DesigningHongKong.com

CB(1)2042/09-10(02)

Following are our comments on the progress report on Kai Tak Development.

PEDESTRIAN FACILITIES IN KAI TAK DEVELOPMENT

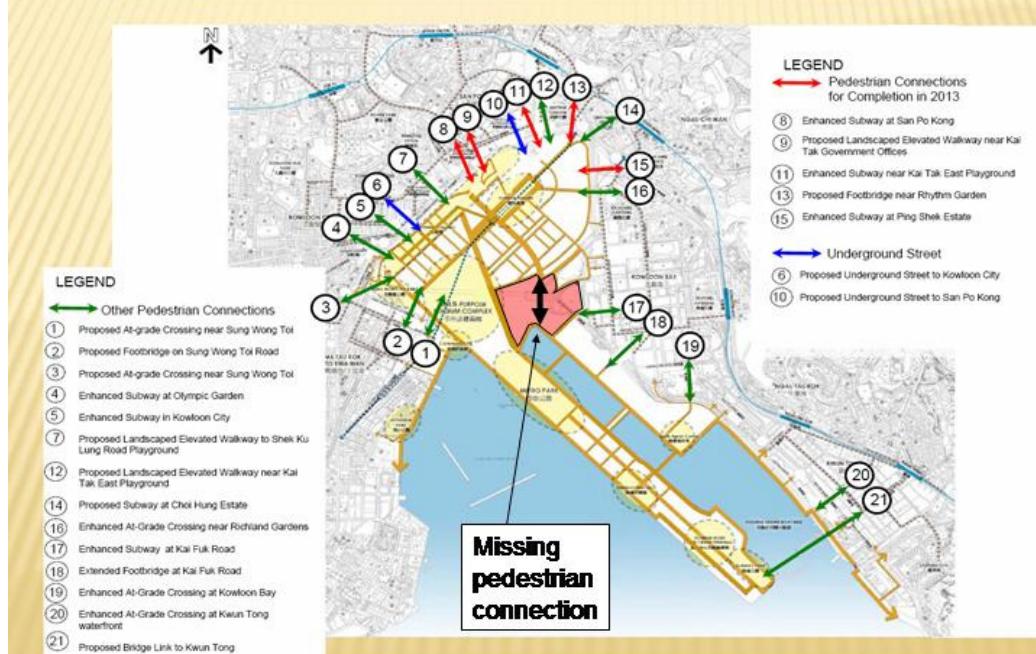
Re 13: Connect the Kai Tak River with the Approach Channel

A direct pedestrian connection between the south-east tip of the Kai Tak River and the Kai Tak Approach channel is needed to avoid a 'dead-end':
